Access Compliance Report Public Rights-of-Way (Curb Ramps)

Main Street: ST_JUST_ST Cross Street: ST_BRIDE_WAY Location: NE

ADA ID: RPRK211110133619 Ramp Type: Type 4 - Parallel Initial Pass/Fail: Pass Overall Compliance: No Severity Score: 25

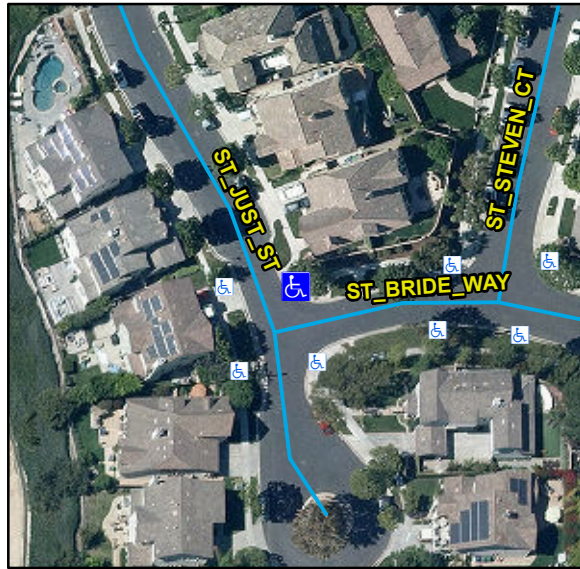
Compliance	Description	Data	Compliance	Description	Data
N/A	Ramp Length LT (in)	122	N/A	Ramp Length RT (in)	126
Yes	Ramp Width LT (in)	54	Yes	Ramp Width RT (in)	54
Yes	Ramp Run Slope LT (%)	7.8	Yes	Ramp Run Slope RT (%)	4.6
Yes	Ramp Cross Slope LT (%)	1.5	Yes	Ramp Cross Slope RT (%)	1.4
N/A	Landing Present	No	No	DWS Provided	No
N/A	Landing Length (in)	N/A	N/A	DWS Contrast	N/A
No	Landing Width (in)	N/A	N/A	DWS Length (in)	N/A
No	Landing Run Slope (%)	N/A	N/A	DWS Full Width	N/A
No	Landing Cross Slope (%)	N/A		DWS Offset Type	N/A
N/A	Landing Movement Obstructed?	No	N/A	DWS Offset Left (in)	N/A
	Landing Movement Type	Curb	N/A	DWS Offset Right (in)	N/A
N/A	Landing Shared	N/A			
N/A	Clear Space	Yes			
N/A	Clear Space To Crosswalk (in)	48			
N/A	Marked Crosswalk 1	No	N/A	Marked Crosswalk 2	No
	Crossing 1 Direction	W		Crossing 2 Direction	S
	Marked Crosswalk 1 Width (in)	N/A		Marked Crosswalk 2 Width (in)	N/A
N/A	Ramp Inside Crosswalk 1	N/A	N/A	Ramp Inside Crosswalk 2	N/A

Crossing 1 Slope (%)	2		Crossing 2 Slope (%)	4.3
	Crossing 1 Cross Slope (%)	0.8		Crossing 2 Cross Slope (%)	2.6
Yes	Gutter Ponding	No	Yes	Curb Slope	1.5
Yes	Gutter Lip Height (in)	0		Road Run Slope (%)	2.2
No	Gutter Run Slope (%)	8.7		Road Cross Slope (%)	5.5
Yes	Gutter Cross Slope (%)	1.5	No	Perpendicular Joint Present	No
Yes	Overall Surface Condition	Acceptable			
	Cross Gutter Present?	No		Spandrel Present?	No
	Replace Cross Gutter?	N/A		Replace Spandrel?	N/A

Remove & Replace Curb Ramp With Two New Directional Ramps or Equivalent. Remove & Replace Gutter.
